Lakeland Power Distribution Ltd. EB-2021-0040

Staff Question-1

Ref: (i) Manager's Summary, Page 22, Table 4

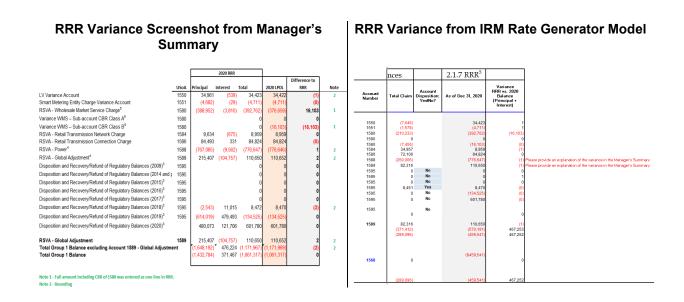
The screenshot explaining variances between the proposed balances for disposition and reported RRR balances provided in the Manager's Summary does not entirely match the data in the IRM Rate Generator Model. Screenshot comparisons of what was filed in the Manager's Summary and the IRM Rate Generator Model are provided below for reference. Please identify whether the data in the Manager's Summary or the IRM Rate Generator Model is correct. As part of the response, please provide any necessary updates to either the table in the Manager's Summary or IRM Rate Generator Model, as applicable.

LPDL Response: LPDL confirms that the table in the Rate Generator Model is correct and a revised table explaining the difference between RRR filing and proposed disposition has been submitted within the IRM Amendment.
